UNITED STATES PATENT AND TRADEMARK OFFICE

APPLICATION NO.	FILING DATE	FIRST NAMED INVENTOR	ATTORNEY DOCKET NO.	CONFIRMATION NO.
10/528,399	03/17/2005	Richard Alan Walker	AP052-05	4280
29689	7590	08/20/2007		
DAVID A. GUERRA			EXAMINER	
INTERNATIONAL PATENT GROUP, LLC			WENDELL, MARK R	
2025 17TH AVENUE N.W.				
CALGARY, AB T2M 0S7			ART UNIT	
CANADA			PAPER NUMBER	
			3609	
			MAIL DATE	
			DELIVERY MODE	
			08/20/2007	
			PAPER

Office Action Summary	Application No.		Applicant(s)	
	10/528,399		WALKER, RICHARD ALAN	
	Examiner		Art Unit	
	Mark R. Wendell		3609

DETAILED ACTION

**FIG. 7**

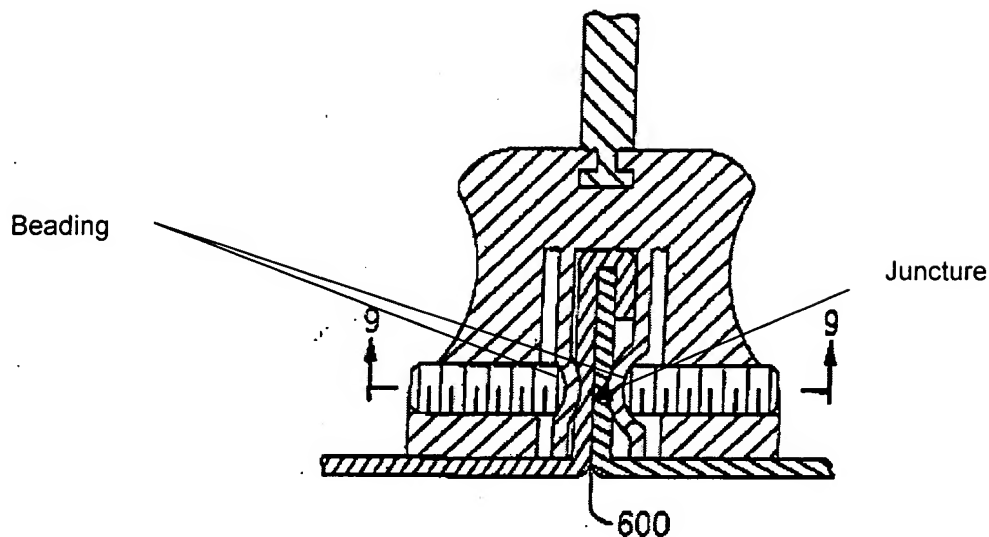
Regarding claim 7, Alley illustrates in Figure 7 a connector system (10) according to claim 1 wherein the connector member (200) has a T shaped end with the slot medially located (300), the T-shaped end include peripheral longitudinal beading (see modified Figure below) that contacts the body (600).

Regarding claim 8, Alley illustrates in Figure 7 a connector system according to claim 1 wherein the connector member has arms (401, 411) projecting from the narrow intermediate section (300), there being a juncture between the arms and the intermediate section, there being a small slot at the juncture of the arms being adapted to close or partially close as the arms are biased (see Figure above).

Regarding claim 9, Alley illustrates in Figure 7 a connector system according to claim 1 wherein the connector member has arms (401, 411) projecting from the narrow intermediate section (300), each arm having a bead (see modified Figure above) extending along an edge of the arm, the bead providing a focal line for the bias.

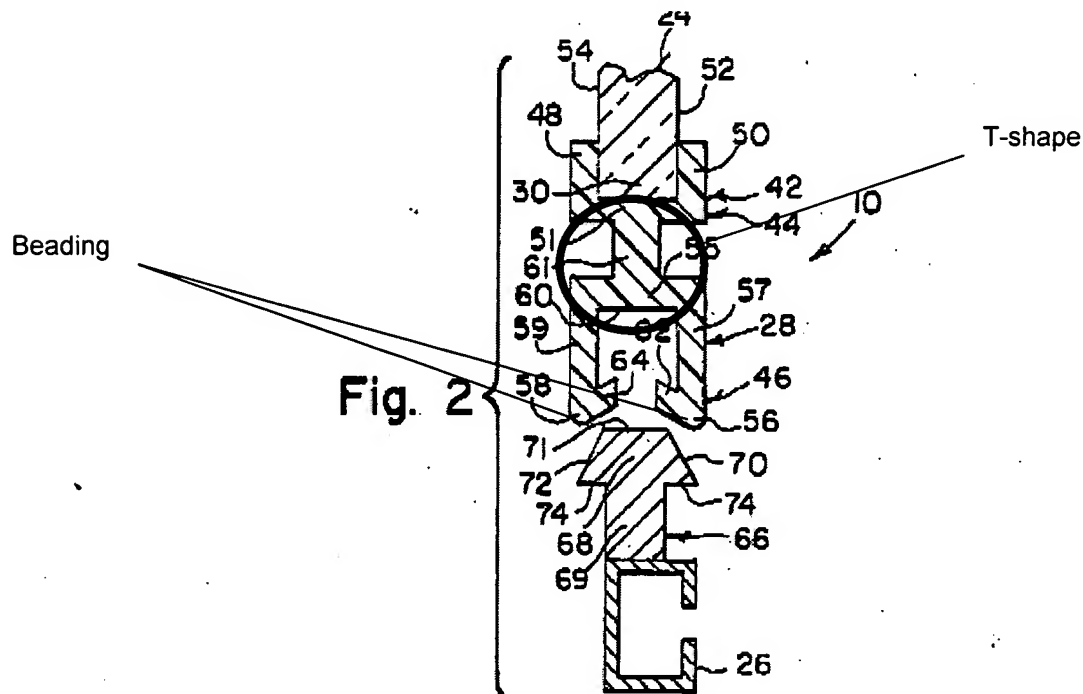
Regarding claims 7 and 9, Gold illustrates in Figure 2 a connector system (10) according to claim 1 wherein the connector member (28) has a T shaped end with the slot medially located, the T-shaped end include peripheral longitudinal beading (see modified Figure below) that contacts the body (68) providing a focal line for the bias.
